ASSESSMENT REPORT:

***State Significant Development Application
Block 4 South, Central Park, Chippendale (former
Carlton United Brewery)***

(SSD 5700-2012)

Director General's
Environmental Assessment Report
Section 79C of the
Environmental Planning and Assessment Act 1979

Figure 6: East-west cross section through the proposed building looking from the south

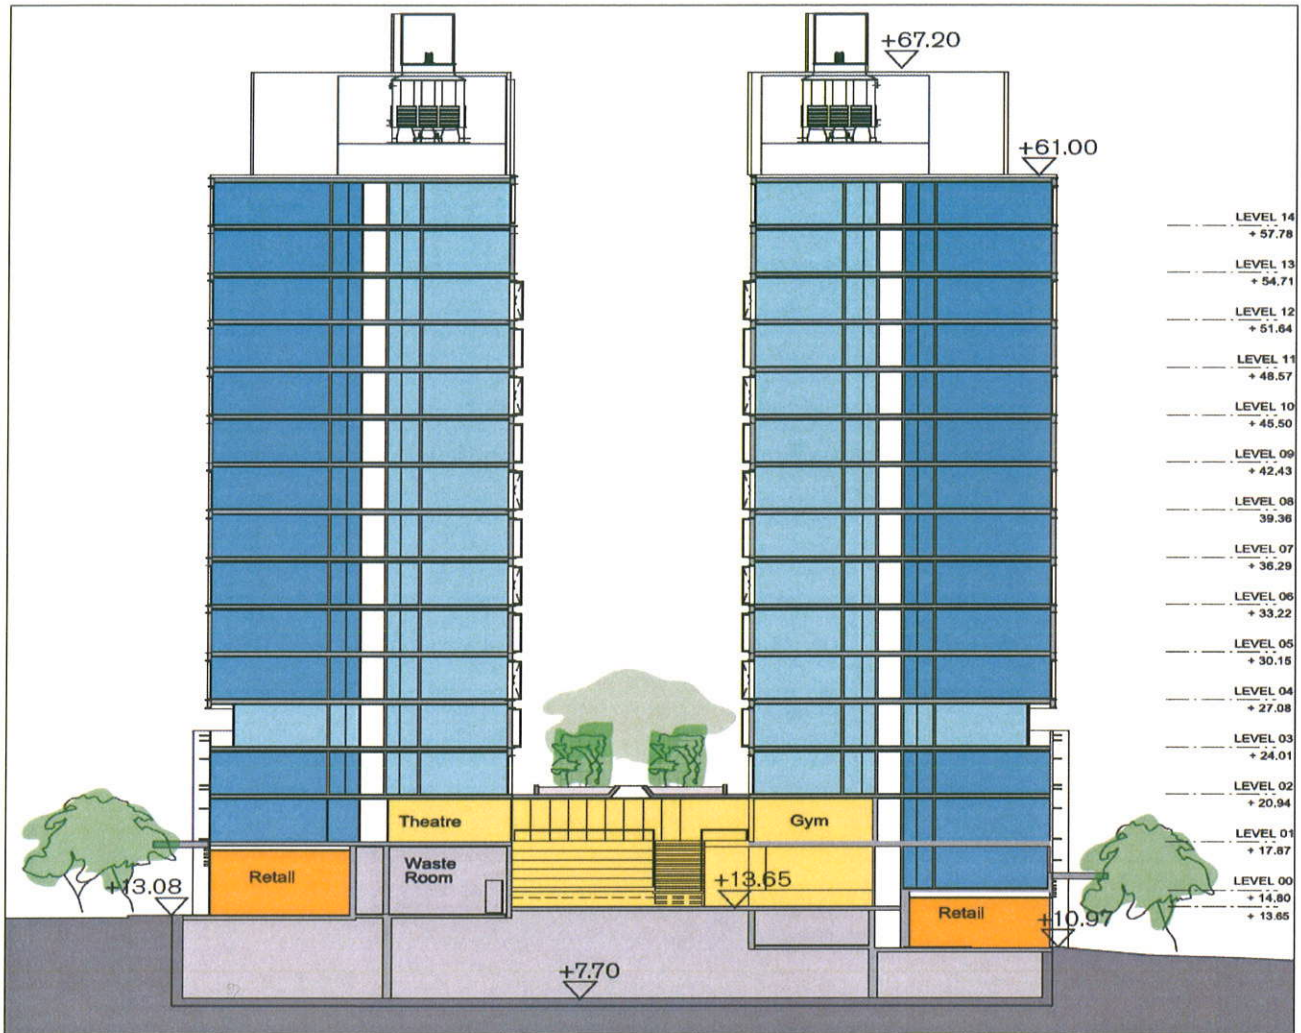
The proposal provides a part 15 and part 16 storey building separated by a central atrium providing an internal separation of 12.7 metres (**Figure 6**). A comparison of the modified Concept Plan building envelope and the proposal is provided at **Figure 7**.

The modified Concept Plan allows a maximum building height of RL 71.5AHD and parapet height of RL60.5 AHD at the western elevation and RL67.5 AHD at the northern elevation.

The proposed building has a maximum height of RL 71.45 AHD and consistent parapet height of RL61.00 AHD with plant machinery rising above the parapet at RL 67.65 AHD. The department considers the variation in roof form at the upper level to be acceptable and is generally consistent with the Concept Plan (as modified) whereby Block 4S steps down in height from Block 4N to provide a transition in building heights towards Block 8 to the south.

The department considers the proposed building height to be generally consistent with the modified Concept Plan.

Figure 8: Plan showing separation distance between Block 4S (bottom) and 4N (top) at the northern footprint of Block 4S with the approved Concept Plan footprint marked in dash red

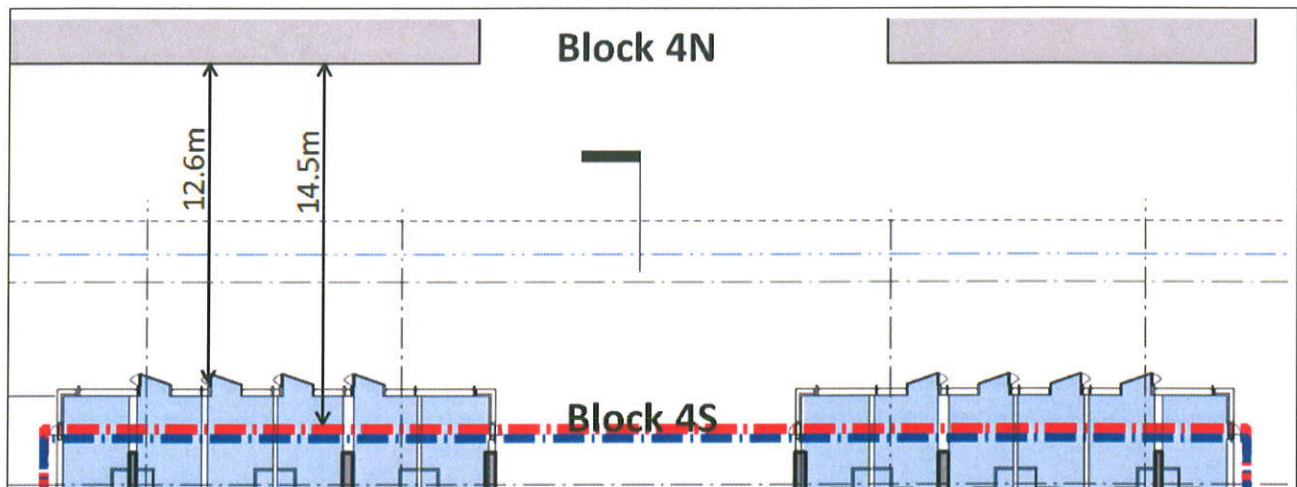
The proposed building envelope is generally consistent with the proposal to modify the Concept Plan in that it seeks a reduced building separation between Blocks 4S and 4N by allowing the footprint of 4S to be extended further to the north by 1.9 metres. The proposed building footprint provides a 12.6 metre building separation (**Figure 8**).

It is noted however, the department's assessment of the modified Concept Plan has recommended that a reduced building footprint at the northern elevation be provided for Block 4S to maintain the building separation of 14.5 metres between Blocks 4S and 4N, under the approved Concept Plan.

The department has considered the applicant's arguments but remains concerned at the overall visual bulk of the building form presented to Abercrombie Street. The department considers the reduced separation between Blocks 4S and 4N enhances the street wall effect of the two buildings along Abercrombie Street (**Figure 9**) and the reduced separation will reduce the quality of the public domain.

The department considers that the building footprint of Block 4S should be reduced at the northern elevation to comply with the department's recommendations in relation to the modified Concept Plan for the following reasons:

In this regard, the department has recommended a condition requiring modified plans to be submitted to the department prior to the issue of a Construction Certificate illustrating a 14.5 metre building separation distance.

Figure 10: Extract elevation from Abercrombie Street showing Block 4N (left) and 4S (right) and the datum lines established at the podium level to mirror those of the adjoining heritage item (Australian Hotel).

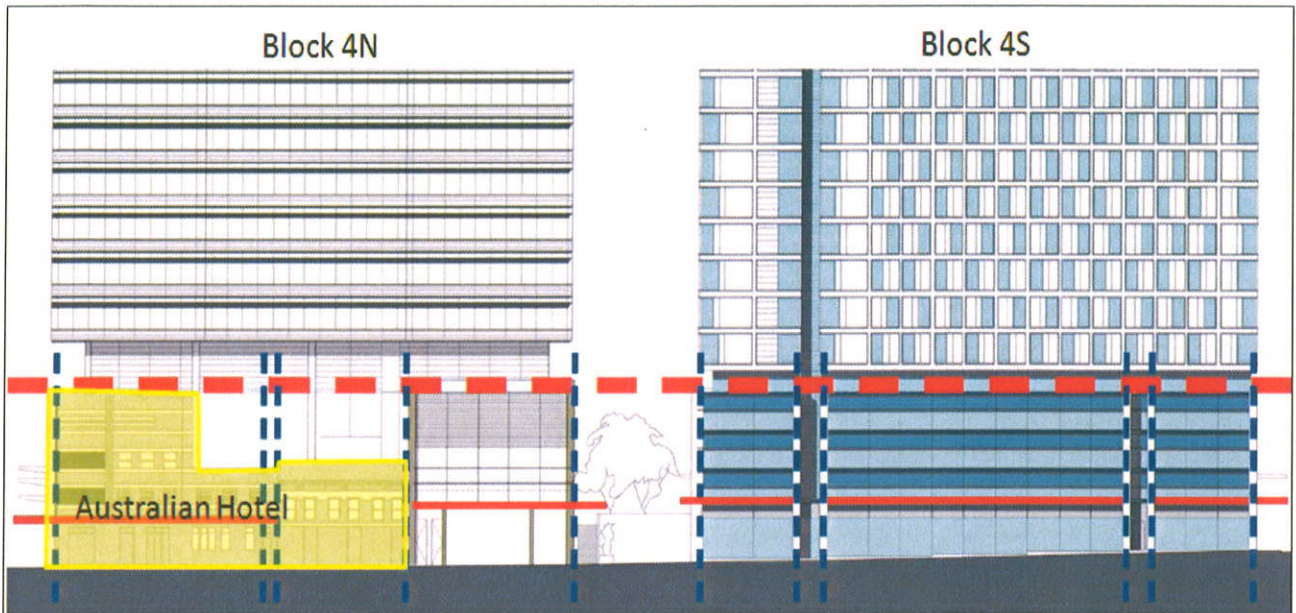
The proposal presents a 16 storey building height at Abercrombie Street comprised of two façade treatments being lower 5 storey façade and an upper 11 storey façade. The design of the lower 5 storey façade mirrors the linear datum lines of the existing heritage item (Australian Hotel) (**Figure 10**) and acknowledges the scale and materiality of the existing buildings opposite on Abercrombie Street.

The 5th storey has been recessed to provide a break between the lower façade and identify a banding of the new façade for the upper part of the building. The department is satisfied that subject to the recommended increased building separation discussed previously, the final design of the building presented at Abercrombie Street provides a well resolved design which is compatible with the scale of buildings in the area including heritage items.

Figure 11: Proposed design of through site link between Block 4N and 4S with proposed cafe tenancy highlighted in red and recommended increase in retail tenancy highlighted in yellow

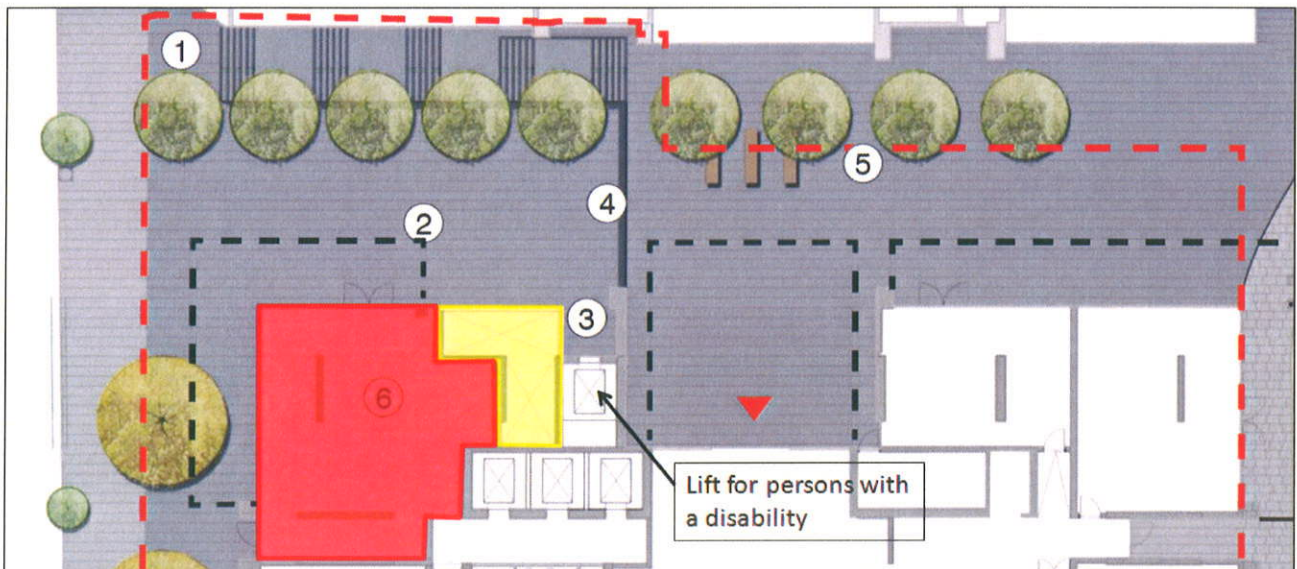
The department notes that the through site pedestrian link between Blocks 4N and 4S will be a main pedestrian thoroughfare for access to the student accommodation building, Abercrombie Street and the greater Central Park site. The through site link comprises a staircase at the southern edge of Block 4N with new paved open space courtyard areas at the lower ground level of Abercrombie Street and upper ground level (**Figure 11**) of Central Park.

These new spaces are activated through provision of retail and café tenancies that front the spaces. The department notes however that the café proposed to be located at the lower ground floor tenancy does not directly front onto a significant portion of the new open space. The department recommends that the tenancy frontage to this space be expanded as per **Figure 11** to allow for better activation of the space. A condition has been recommended accordingly.
